# Response to Technical Review Comments

## Clear River Energy Center and Burrillville Interconnection Project

Application No. 17-0079

**Re: Clear River Energy Center, LLC  
Burrillville RI  
Application No. 17-0079**

SHEET	01C001
	2 OF 18

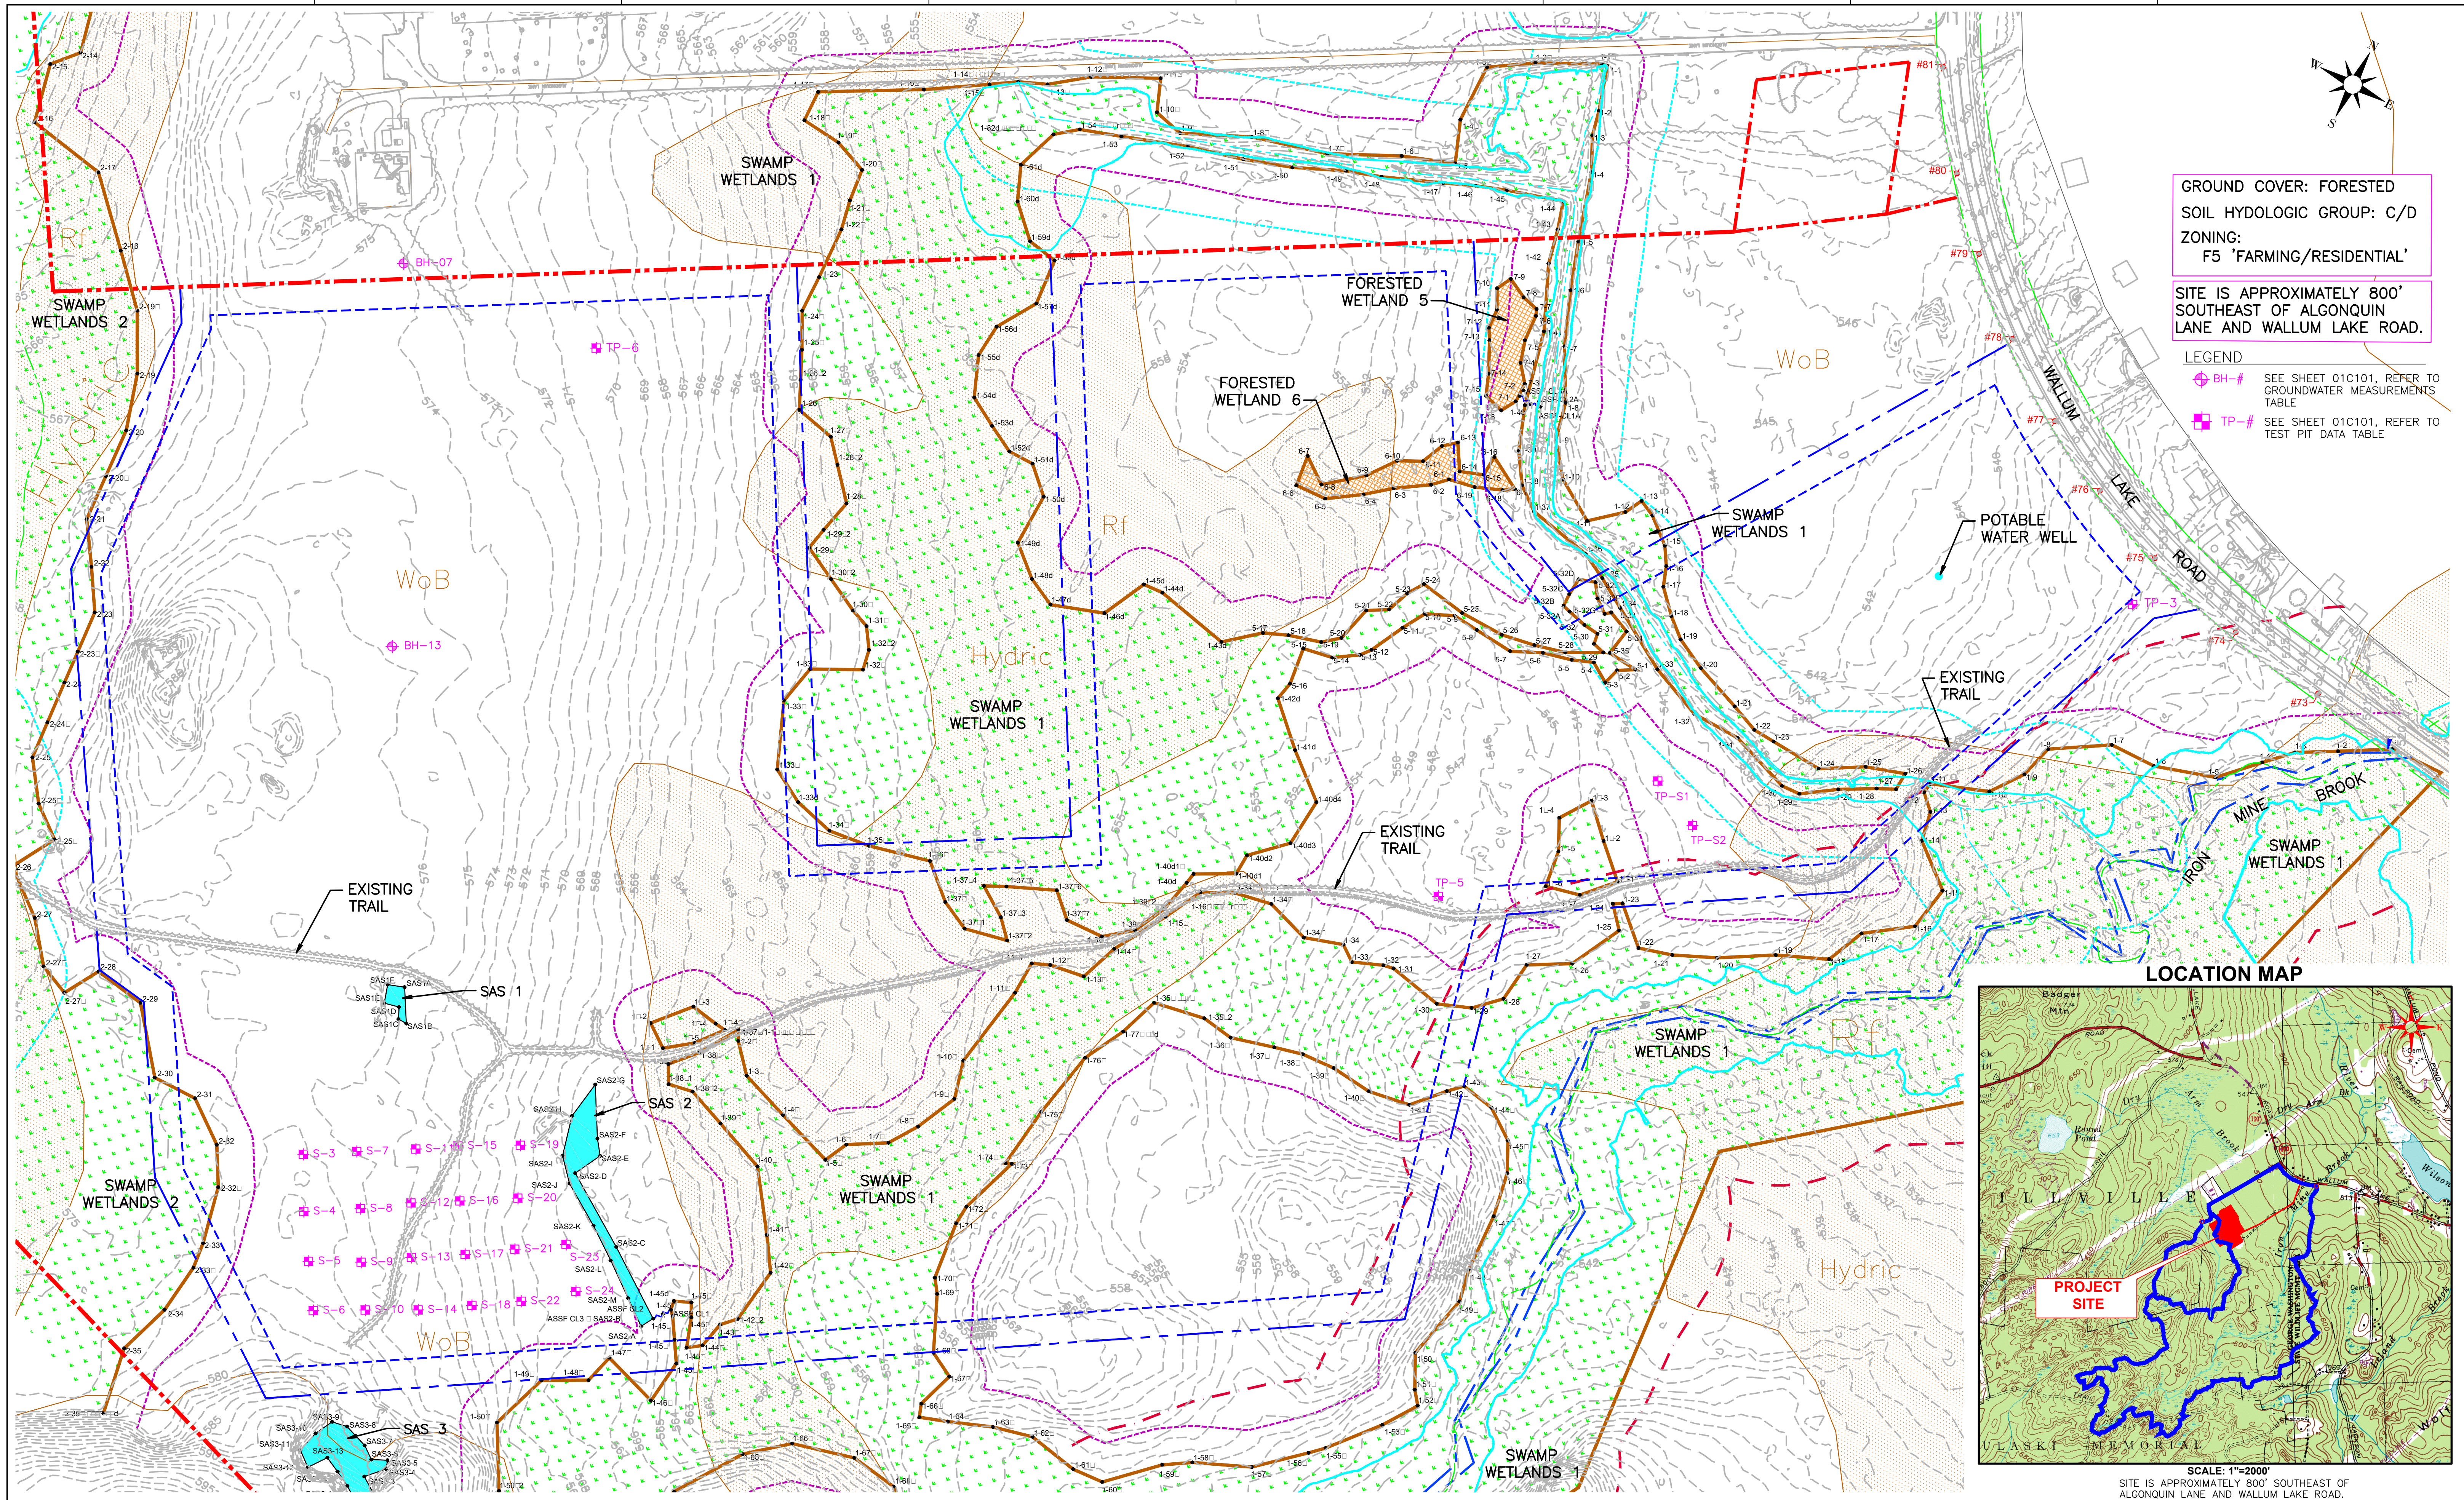
**Response:** The Flood Plain Mitigation Area has been added to the Legend sheet (Sheet 2 of 18).

SHEET  
01C200  
5 OF 18

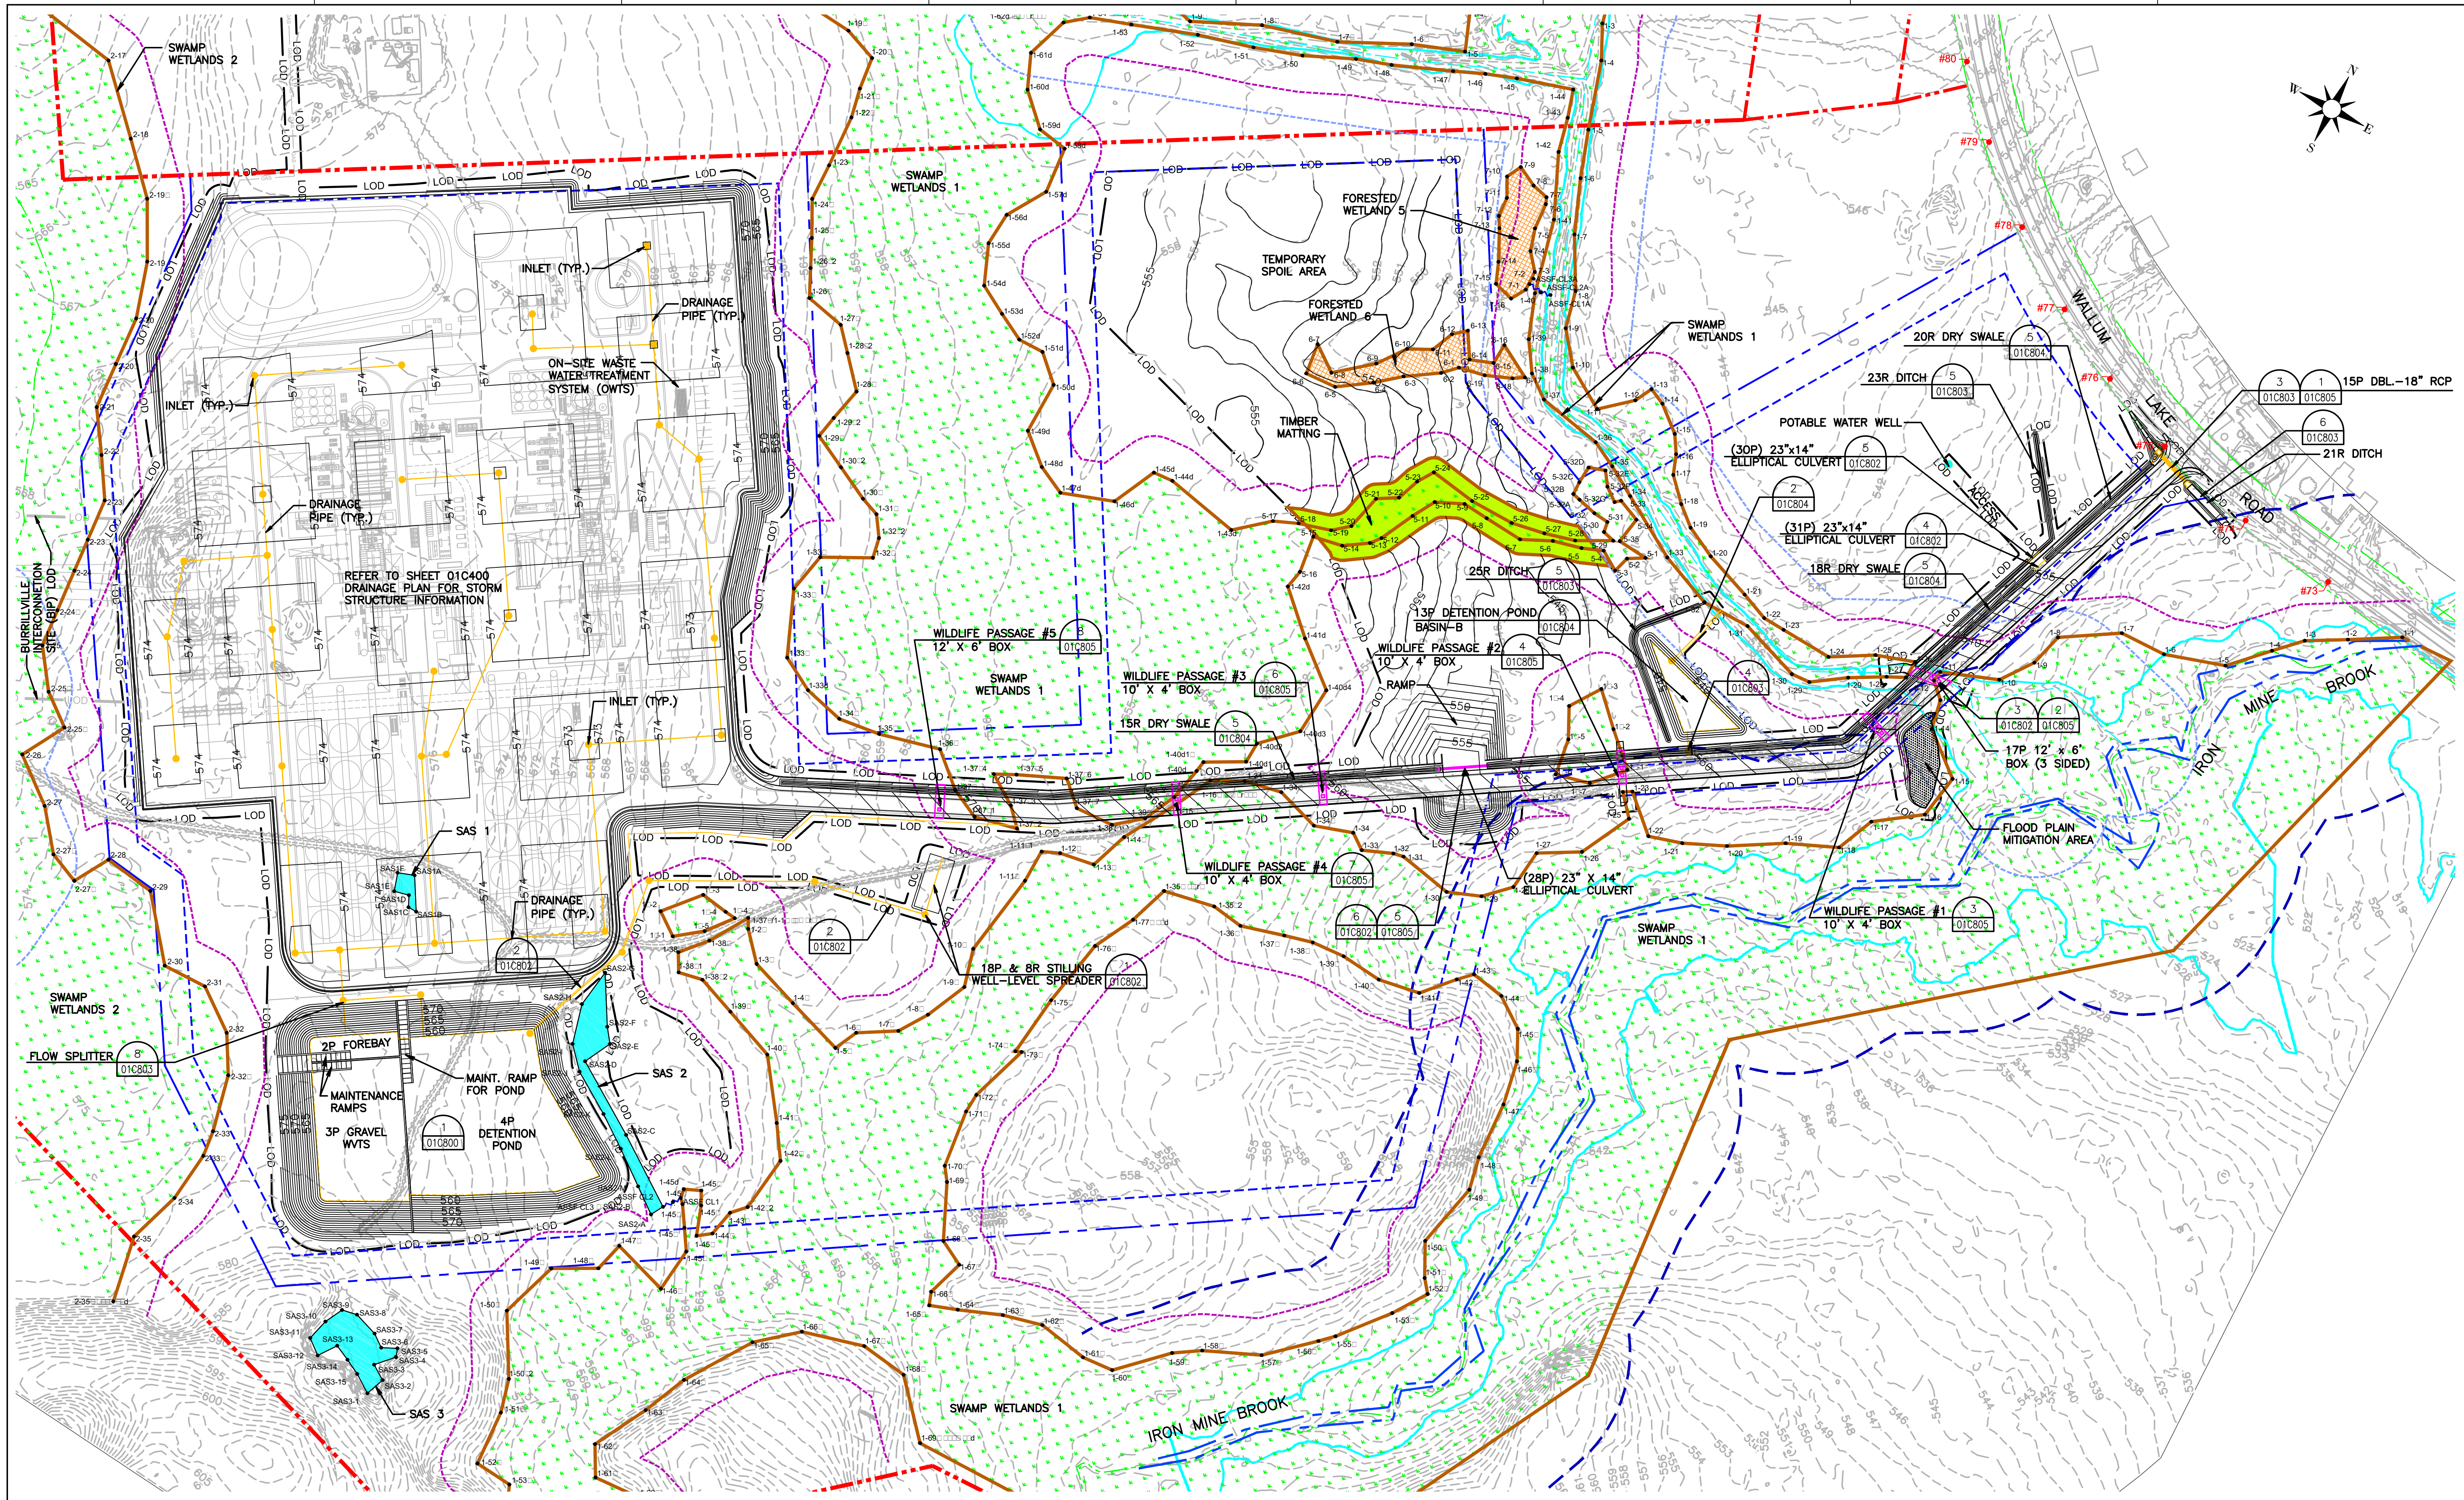
**Response:** The Roadway Plan and Profile sheets (Sheets 8 and 9 of 18) as well as the Utility sheet (Sheet 5 of 18) now show the proposed water and electric lines. Note that the electric line is labeled Under Ground Electric (UGE) and the Water Line as "W". The distribution of these utilities within the footprint of the plant will be designed by the EPC contractor at a later date, along with the rest of the underground utilities.

SHEET  
01C300  
6 OF 18

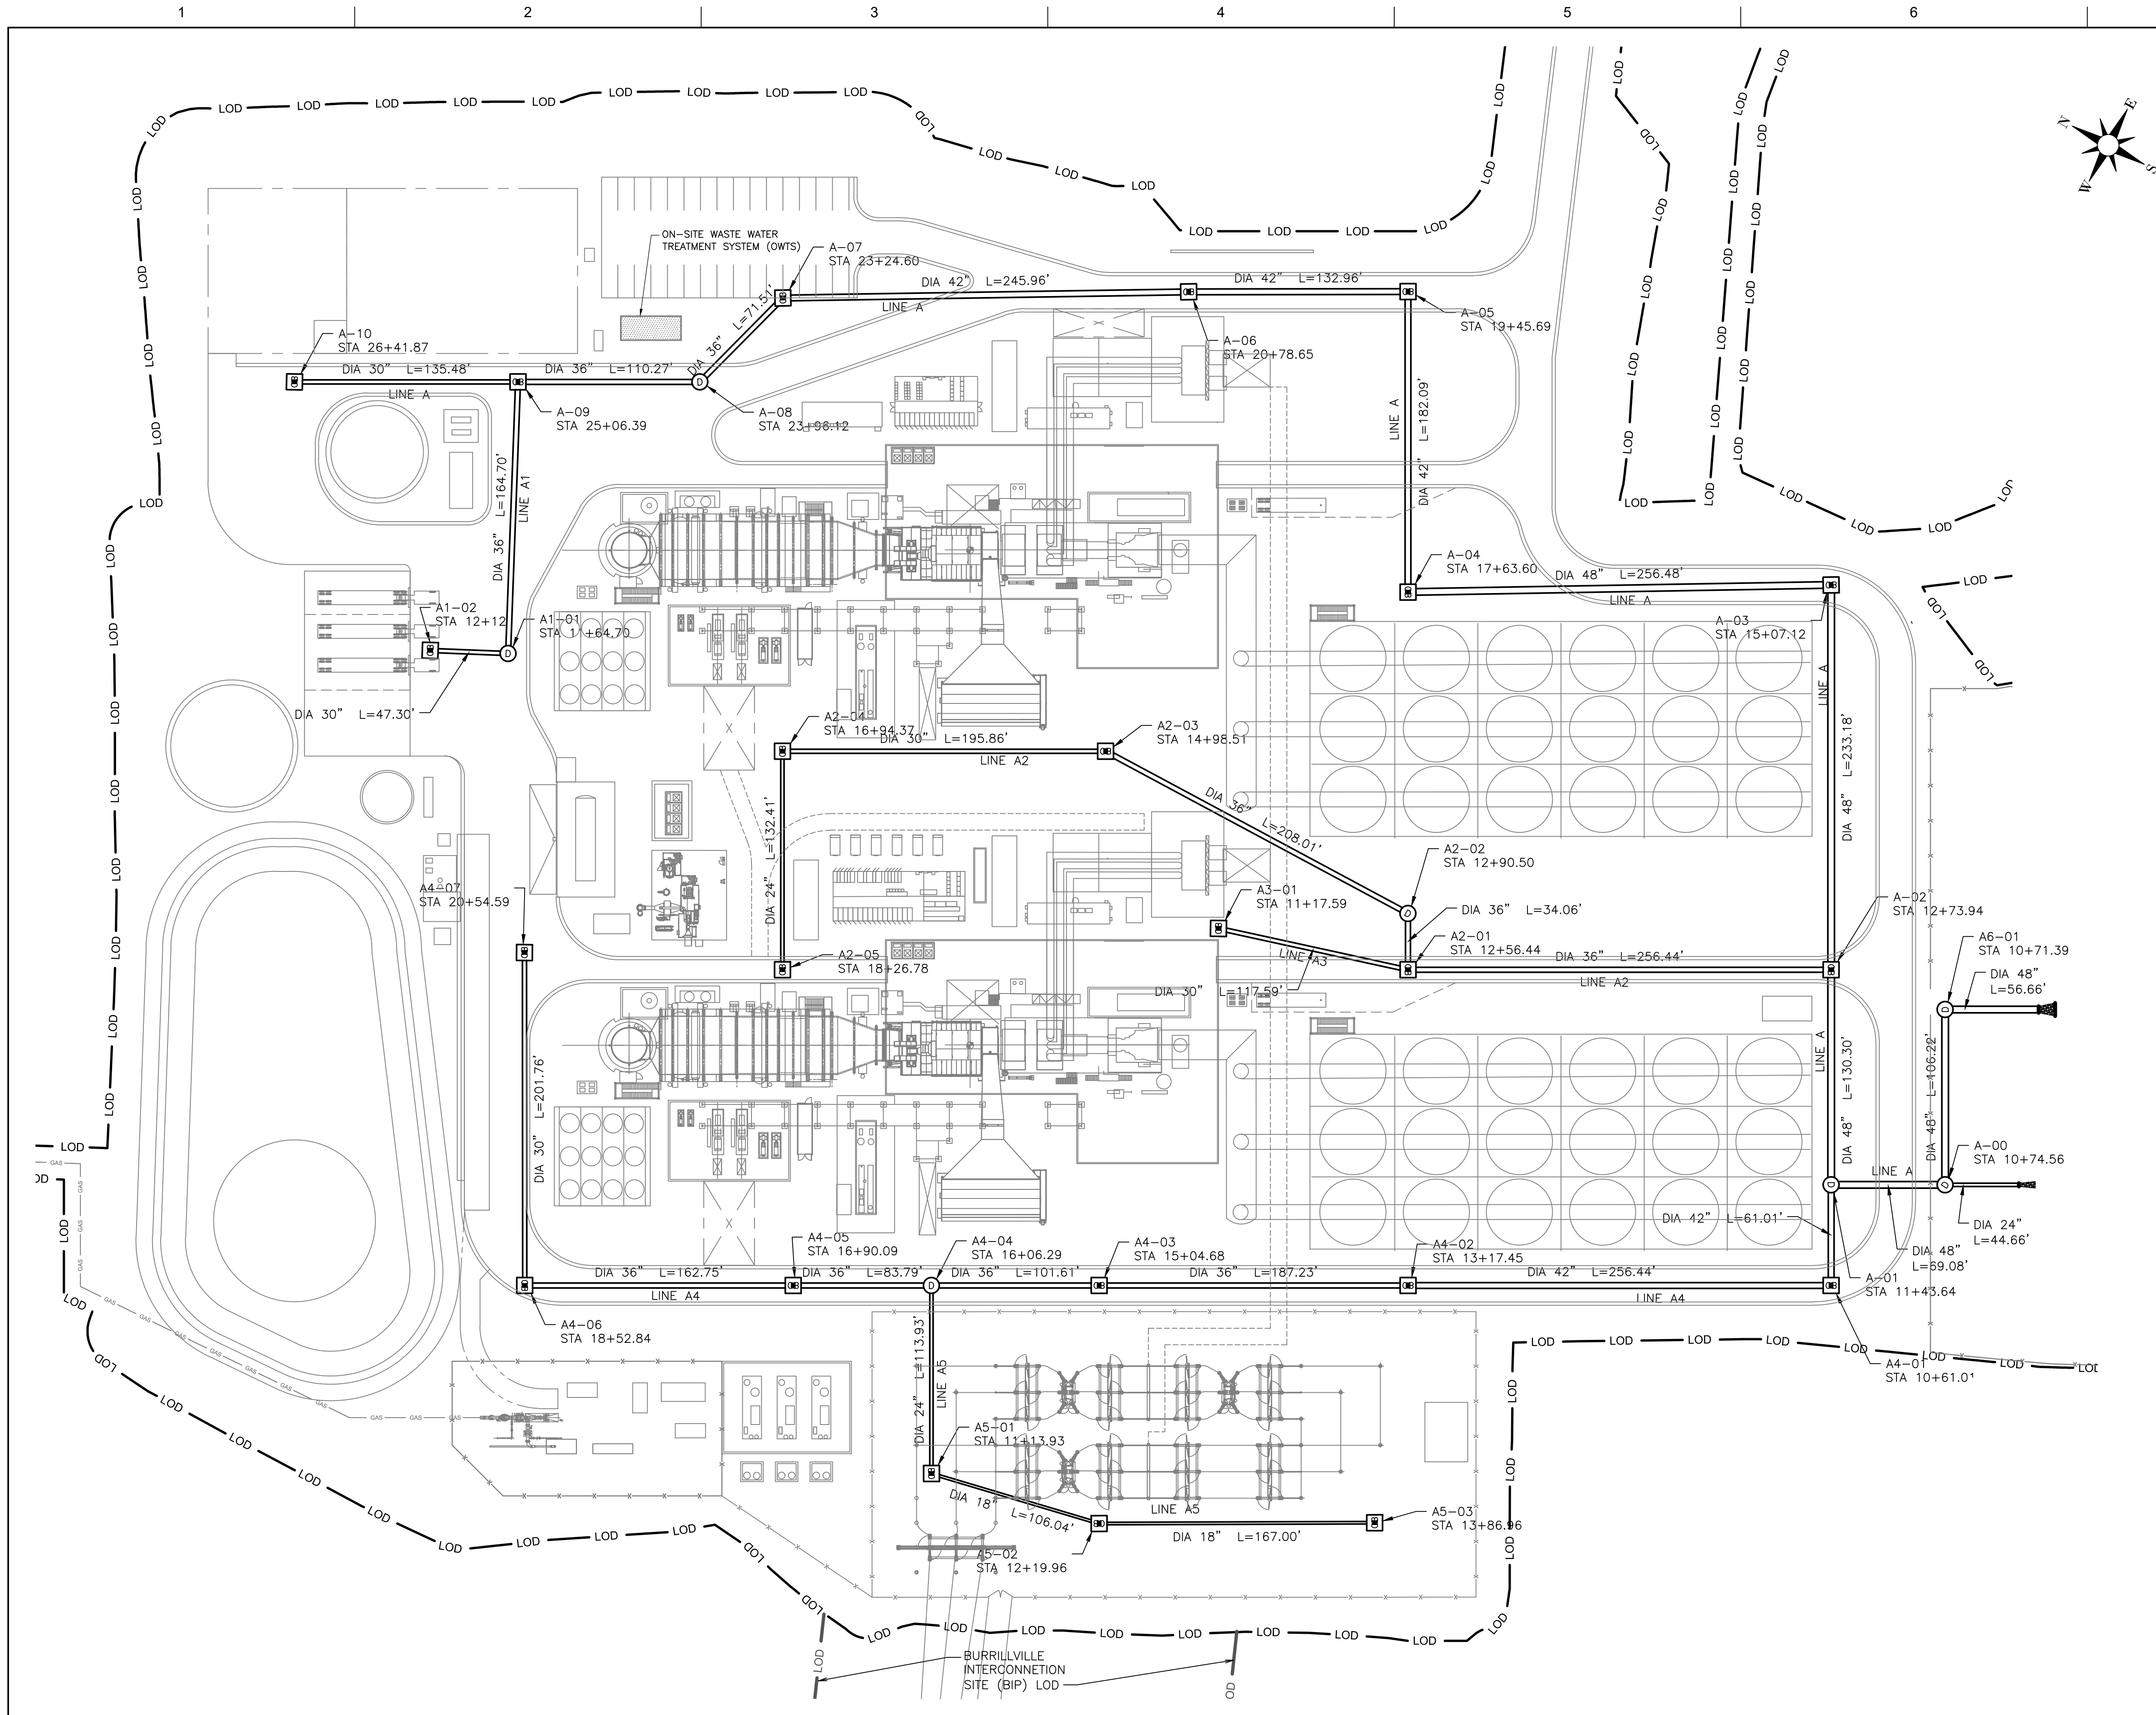
**Response:** The break in the LOD line and an explanatory note have been added to the Proposed Grading Plan (Sheet 6 of 18) and on the Proposed Drainage Plan (Sheet 7 of 18) (see Exhibit 1 Volume 1).
